Ultra96-V2-Errata概要-

Ultra96-V2

Figure 3 – Ultra96-V2 Schematic Page for Pmic #2, 0x14

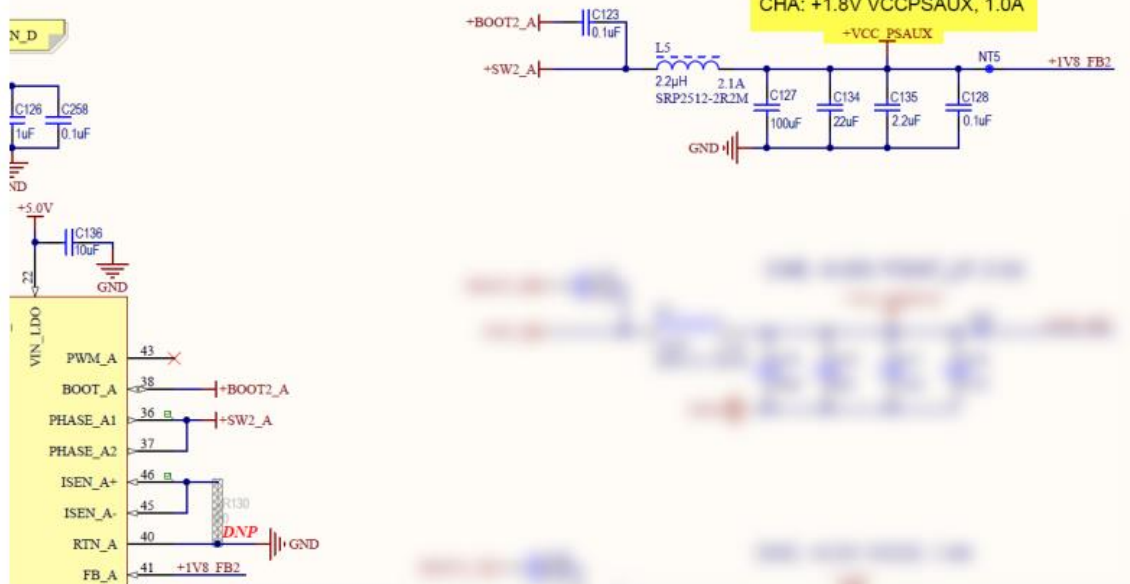
PMICの過電流Warningが出る

-Pmicの閾値の設定値が低すぎたため、電流がスパイクした際に、warningのトリガーとなっております。

-評価ボードを使用する上では、問題ないので、無視してください。Warningを消したい際には、閾値を1.5Aに設定してください。

Ultra96-V2 Quick-Start

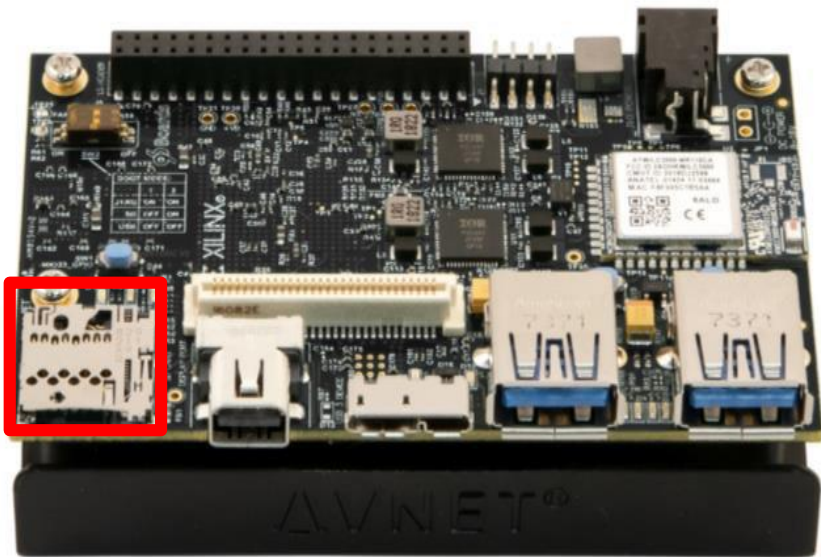
-左記付属カードに誤記があります。Step8にて、電源オフにした場合、すべてのLEDが消えると書いてありますが、実際には、D17は光つづけます。（電源アダプタが挿さっている限り）

-<http://ultra96.org/support/documentation/28476>よりUpdateされた Quick Start Cardをダウンロードしてください。

Figure 1 – Ultra96-V2 Backside (Bracket Removed)

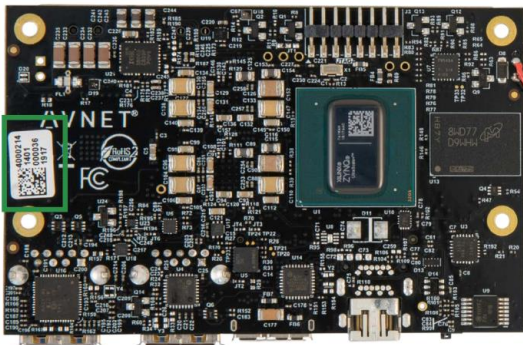
-赤枠のSDカードケージにて、付属SDカードの出し入れがスムーズに行われない場合があります。(全てのボードに見れる現象ではありません。)

-ボード裏に記載してある製造日ラベルの4桁番号を確認してください。(左記緑枠なし、その下の拡大図)

-付属のSDカードより、出し入れスムーズなSanDiskマイクロSDカードをご提供いたします。(ご希望の際は別途支給の為、ご連絡ください)
